## Issues with Applicants' Glint and Glare Methodology and Assessment

Solar Photovoltaic Glint and Glare Study

Bovley West Solar Farm 213

Figure 116 Reflective panel areas and screening for dwellings N14 to N35

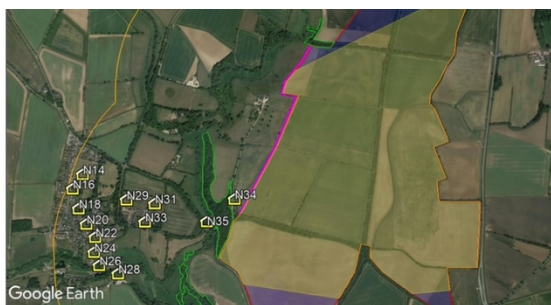
A typical example from this table is shown below. I have visited several of these properties and can confirm that, for example, M34 has NO existing vegetation to screen it but is shown as no impact with no mitigation recommended. The “proposed vegetation” would offer no protection for 10 years. In contrast, M36 is judged as having no significant screening and therefore moderate impact with recommended mitigation. Again, I have visited this property and there is existing vegetation that would partially screen it from day one. The mitigation merely filling the gaps or allowing the present 1m hedge to grow. Surely any property recommended for proposed vegetation that requires proposed vegetation, which would not provide protection from any glint and glare for 10-15 years, should be the one classified as at least “moderate impact”?

Fig.1 N34 pink line = “proposed vegetation”  
No impact, no mitigation recommended

N36 blue line = mitigation recommended  
No significant screening, Moderate impact,
